**RE: Wat Phrathat Doi Suthep NM
Grading and Drainage Plans
Engineer's Stamp Date: No stamp
Hydrology File: K19D125A**

Albuquerque Based upon the information provided in your submittal received 09/22/2022, the Conceptual Grading & Drainage Plan is not approved for Administrative Site Amendment until the following comments are addressed:

C-100

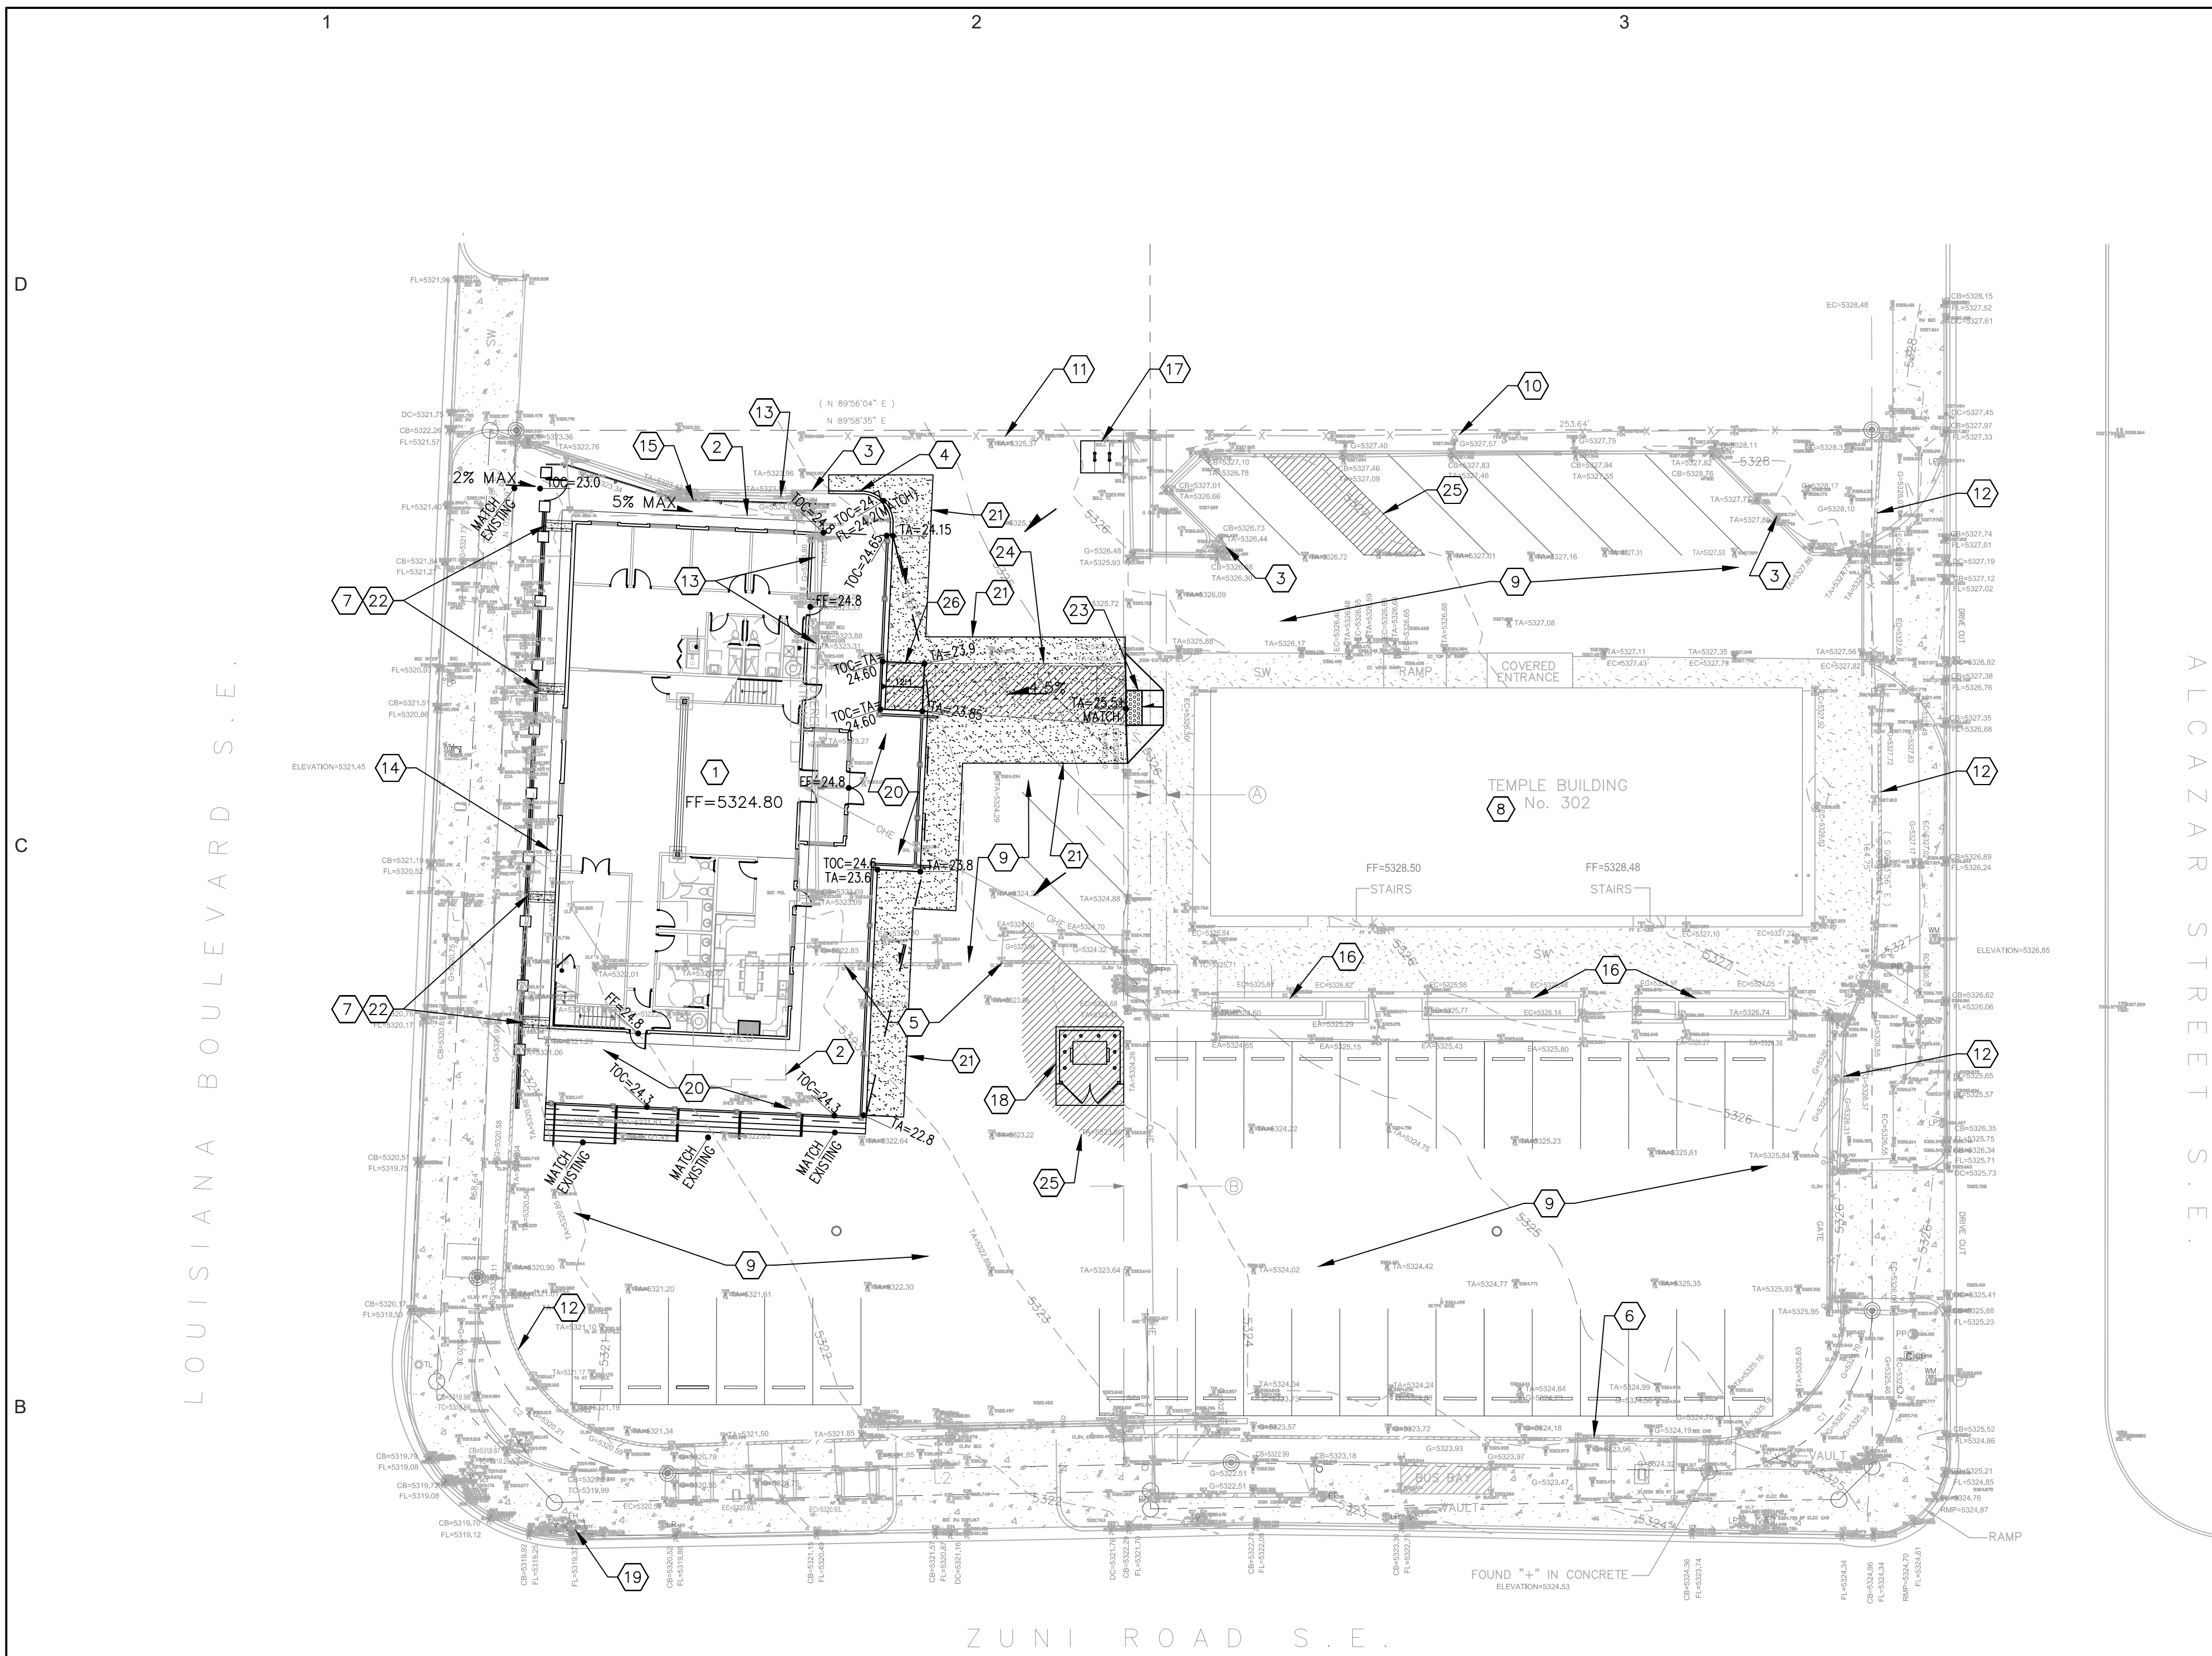
NM 87103 1. Provide for stormwater quality for the proposed impervious area: 0.26" of runoff. Hydrology realizes the area was previously impervious, but when construction is to occur on existing sites stormwater quality must be provided. Provide calculations for the required volume.

www.cabq.gov 2. Remove the Note "There is no stormwater quality volume required...." And remove the statement in the "Conclusions" paragraph that there is no stormwater quality volume required".

3. It appears there is adequate space for stormwater quality between the wall and the sidewalk along Louisiana Blvd. Provide required volume and provided volume.

3. Do you have a typo in the project name? It ends in "MN" rather than in "NM".

A1 CONCEPTUAL GRADING AND DRAINAGE PLAN
SCALE: 1"=20'

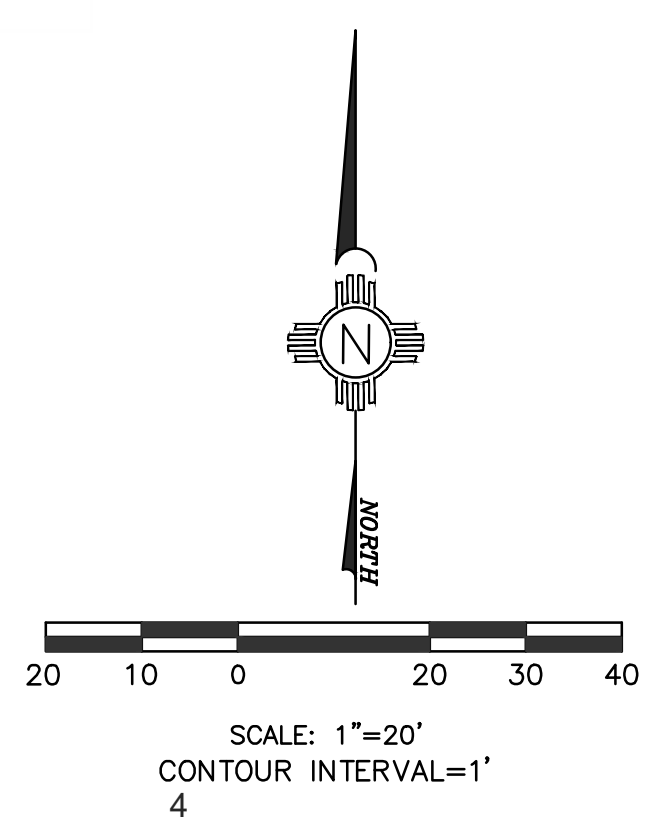
1. Keyed Note 22 states to build a 12" wide concrete channel, but the holes in the wall per Note 7 are only 6" wide. Seems the drainage will run into the wall and back-up.

2. Near the NW corner of the new building, it is not clear, what the 2% and 5% MAX applies to. There is also a TOC grade in this area. Seems like a good place for landscaping/stormwater quality ponding area.
